Introduction

This submission contains several reasons for objecting the “Alexandria Park Community School Redevelopment” SSD Application. The high level reasons for objecting are listed below. Detailed argumentation to support the objective is attached to this objection as PDF.

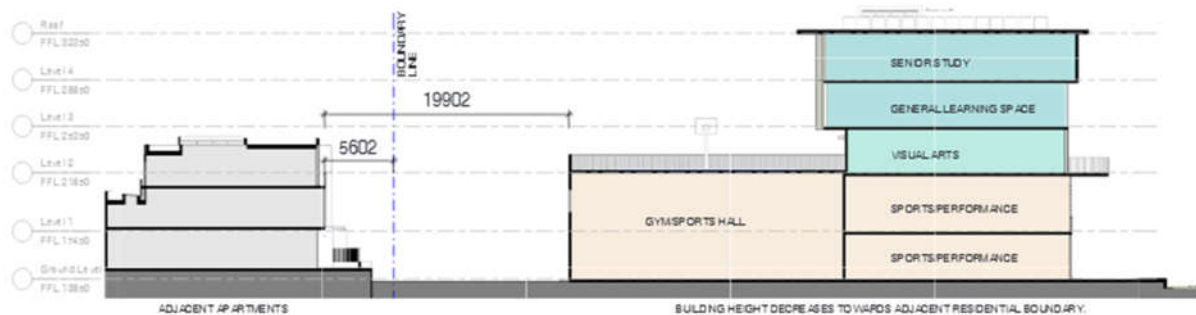
The 4 level view is further contradicted in several of the architectural drawings in appendix where there are suddenly plans with 5 and 3 levels and diagrams with 5 levels without clear indication of height.
